SERVICE BULLETIN

TS-120S

#816

SUBJECT: TS-120S Band Pass Filter Change

▼ RF UNIT (X44-1260-01)

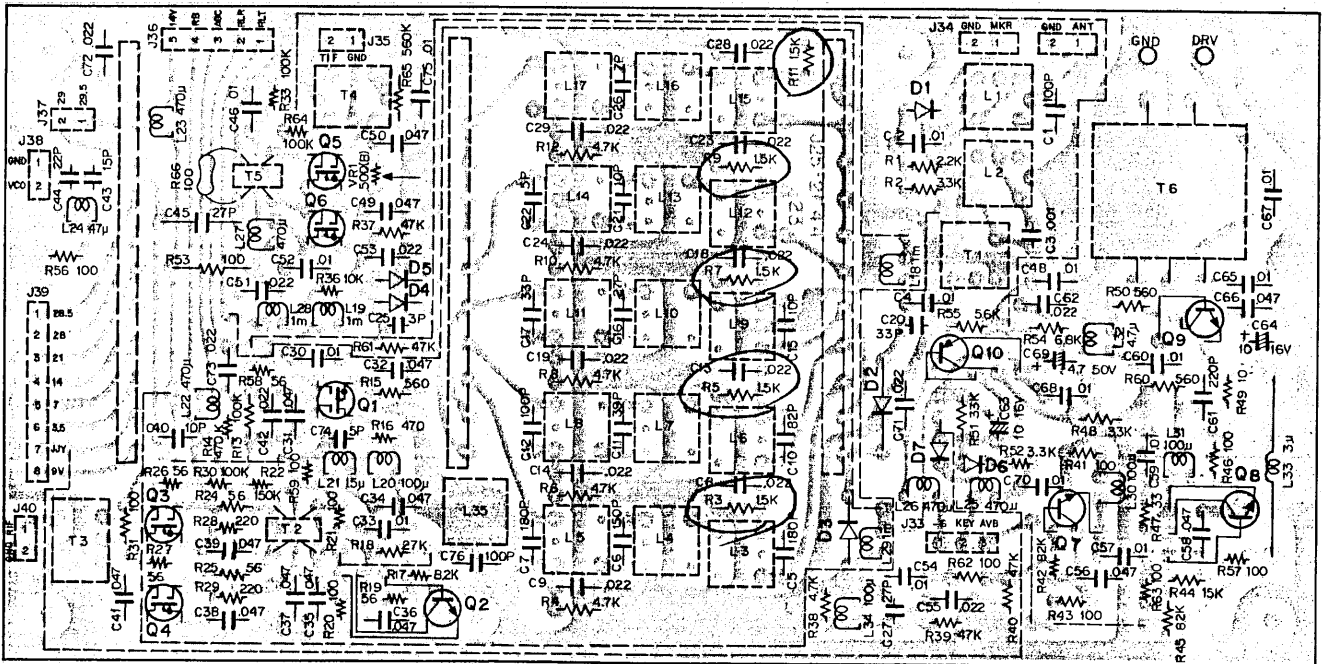
For complaints of out-of-band interference, especially BCI, the BPF (bandpass filter) terminating resistors may be changed for an improvement of approximately 10dB.

On the RF unit X44-1260-01, change R3,5,7,9,11 from 1.5KOhm to 470 Ohm. No adjustments are required.
